R99DJ

Blue Bird Body Company has determined that a defect which relates to motor vehicle safety exist in certain 1999 and 2000 year model Blue Bird LTC 40 coaches. Blue Bird is conducting a recall to correct this defect.

The defect involves the manner in which the overhead parcel racks are attached to the ceiling of the bus on subject buses. The original fasteners may become dislodged allowing parcel racks to fall without warning.

REPLACEMENT INSTRUCTIONS

FIG. 1

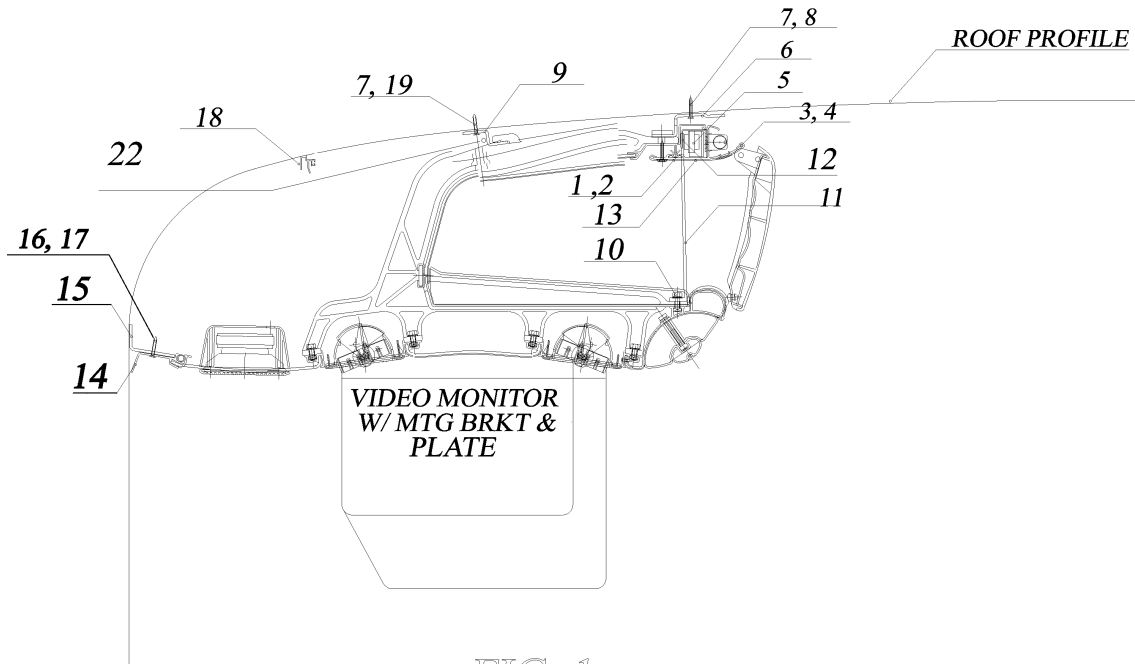
Note: Review Figures 1 and 2 on page 3 of instructions for location of items given in instructions.

24. Remove door-opening support (item 11) at the joint of front and rear parcel rack. Support is secured with 10mm nuts (item 10) and screws (item 12) behind doors.
25. Cut two (2) 2 x 4 supports 67 ¾" long, cover ends with fabric to protect parcel rack and flooring.
26. Install supports under both ends of parcel rack section that is to be removed first.
27. Remove screws (item 16) from extrusions (item 14, 15) at rear flap of parcel rack.
28. Remove screws (item 7) from extrusion (item 6) in ceiling at compartment light access.

29. Slide front parcel rack forward 4" to disconnect speaker wires.
30. Slide parcel rack to inside of coach to disconnect parcel rack from extrusion (item 9) mounted permanently to ceiling.
31. Place parcel rack on top of seats.
32. Remove rear parcel rack repeating steps 27 through 32.
33. Remove screws (item 7) from extrusion (item 9) and drill hole out to ¼" and install rivets (item 19).

34. While parcel racks are down, run a thick bead of sika-flex between extrusion joint (item 18) and roof panels to prevent squeaks between extrusion and roof.
35. Reverse order to reinstall parcel rack.
36. Replace screw (item 16) with rivet (item 17) after drilling hole out to 3/16".

Note: When installing PK screws (item 8) ensure that screws are being fastened into the bow. Bows are spaced 35.0" apart.

37. When replacing sheet metal screws (item 7) with PK screws (item 8) apply Lock-tite on screws before installing in profile.

Figure 2

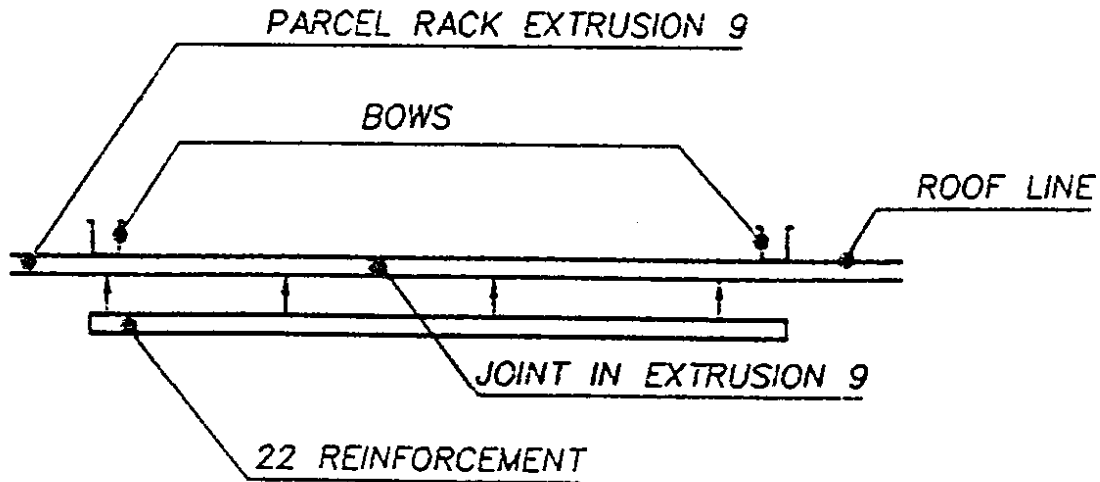
Note: Where joints in the extrusion that attach parcel racks to roof are between bows, install reinforcement angle over joint. See Figure 2.
